**Subject:** FW: HM 404 RE: Weir on Afon Siedi - SN 39084 37863

**Subject:** HM 404 RE: Weir on Afon Siedi - SN 39084 37863

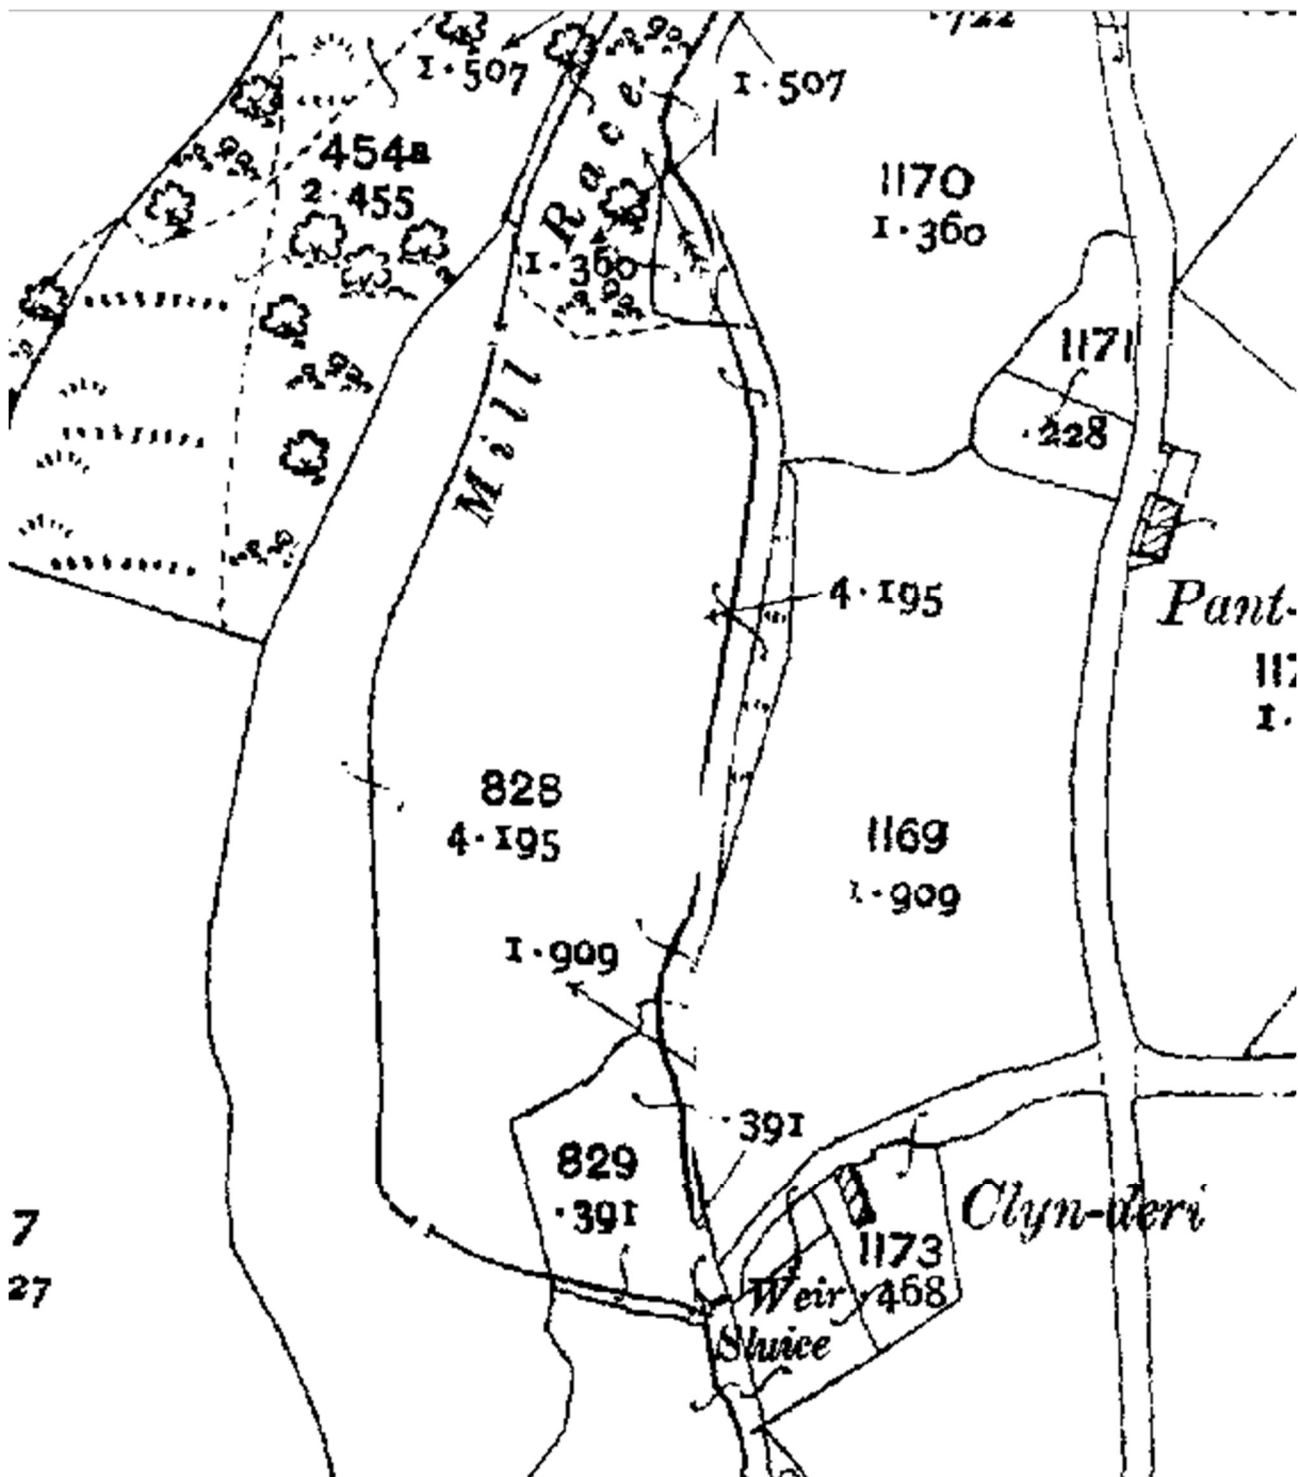
As you are aware, this weir is part of a water management system designed to deliver power to the Woollen factory at Derw Mills, first recorded on the Ordnance Survey maps of 1906 (see map below). I understand that the proposals are to leave the structures in place, but to introduce stone on top to reduce the drops for each of the weirs and provide easier passage for fish.

As the structures therefore essentially are remaining intact, but will be obscured from view, I recommend that you carry out a photographic record of the structures before work commences. This should include general views of the structures, and detail where possible to do so. The site of the sluice gate and former course of the leat where it meets the river should also be recorded.

A photographic record of the works as complete should also be included.

Digital photographs are fine, and should be accompanied with a plan to show the views that the photos are taken from.
